## **OLENSKY ADDITION TO MOBILE SUBDIVISION**

APPLICATION NUMBER 17 DATE April 17, 2003  
 APPLICANT Olensky Addition to Mobile Subdivision  
 REQUEST Subdivision

# OLENSKY ADDITION TO MOBILE SUBDIVISION

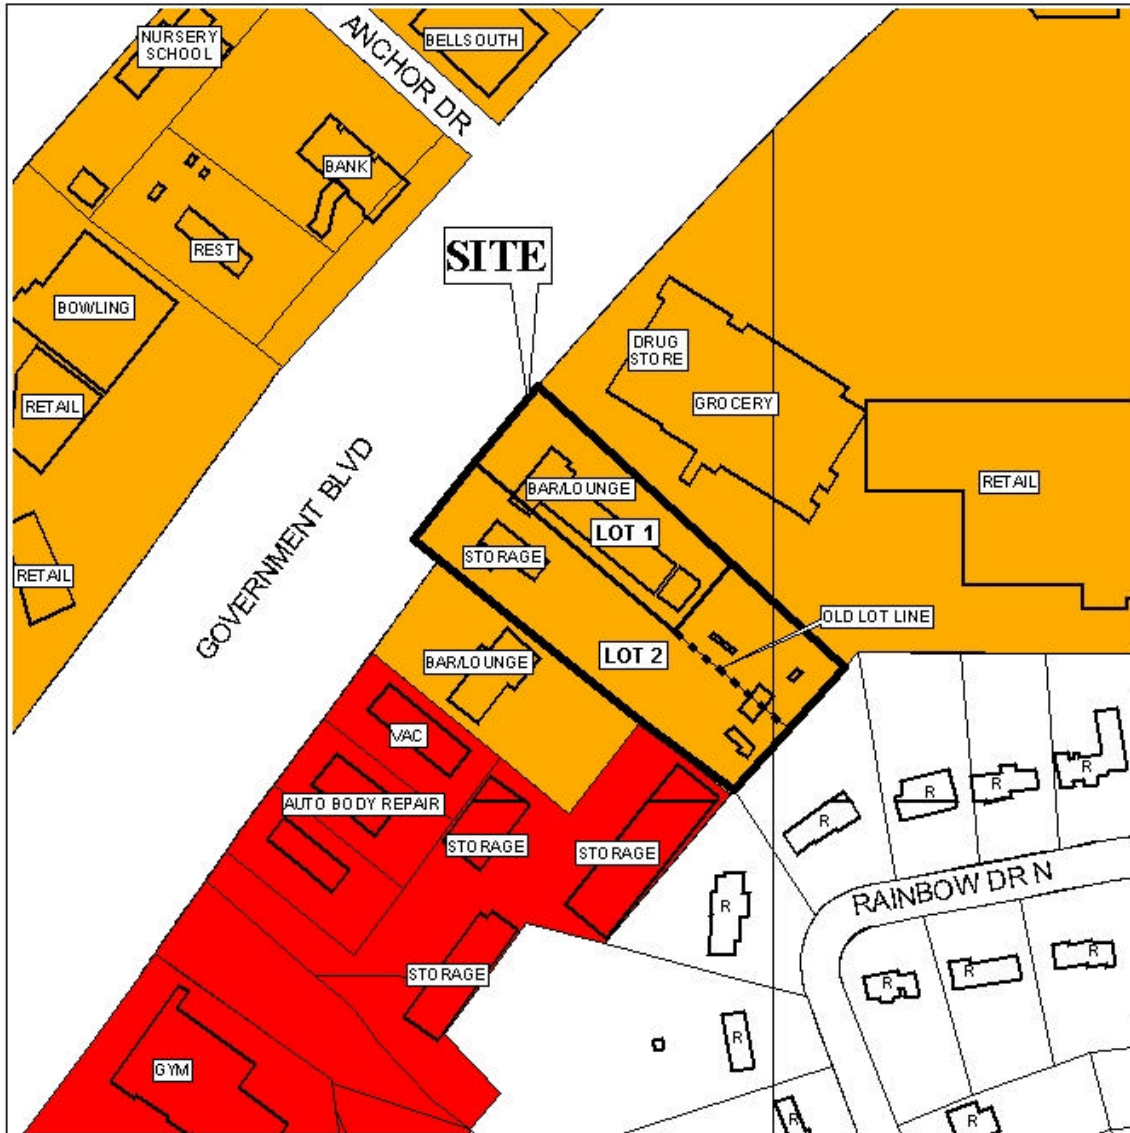
With Lots 1 & 2 having approximately 240' of frontage on a major street, access management is a concern; therefore, a note should be placed on the final plat stating that Lots 1 and 2 are limited to one curb cut per lot each, with the location and design to be approved by the Traffic Engineering Department.

Lot 1 exceeds the maximum width to depth ratio as recommended by the Subdivision Regulations; therefore, a waiver of Section V.D.3. would be required.

With modifications and a waiver of Section V.D.3. for Lot 1, the plat will meet the minimum requirements of the Subdivision Regulations and is recommended for Tentative Approval subject to the following condition: 1) the placement of a note on the final plat stating that Lots 1 and 2 are limited to one curb cut each, with the location and design to be approved by the Traffic Engineering Department.
